70 Series Cruiser Tow Point

Part Number RP-CRU70E

Description 70 Series Tow Point

RP-CRU70E

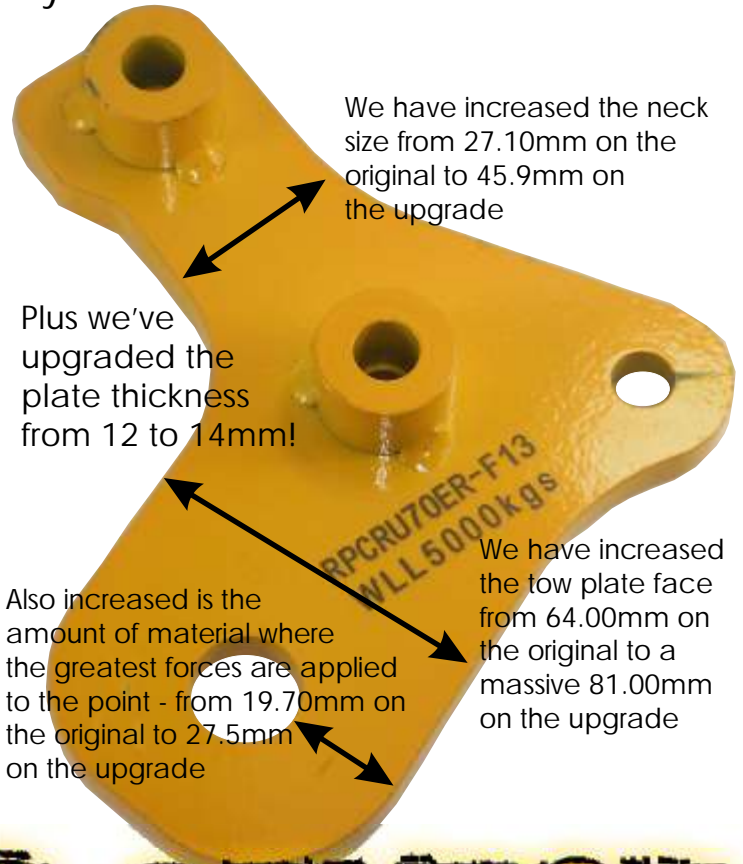
Roadsafe have upgraded the size and length of the replacement Tow Point to suit to the 70 Series Cruisers. This upgrade has been undertaken to allow for the point to protrude further through the bash plate, to allow easier shackle attachment for recovery situations.

Points now protrude through Bash Plate for easier shackle attachment

Overall 16% increase in strength demonstrated during destruction testing

We have increased the neck size from 27.10mm on the original to 45.9mm on the upgrade

Plus we've upgraded the plate thickness from 12 to 14mm!

Also increased is the amount of material where the greatest forces are applied to the point - from 19.70mm on the original to 27.5mm on the upgrade

We have increased the tow plate face from 64.00mm on the original to a massive 81.00mm on the upgrade
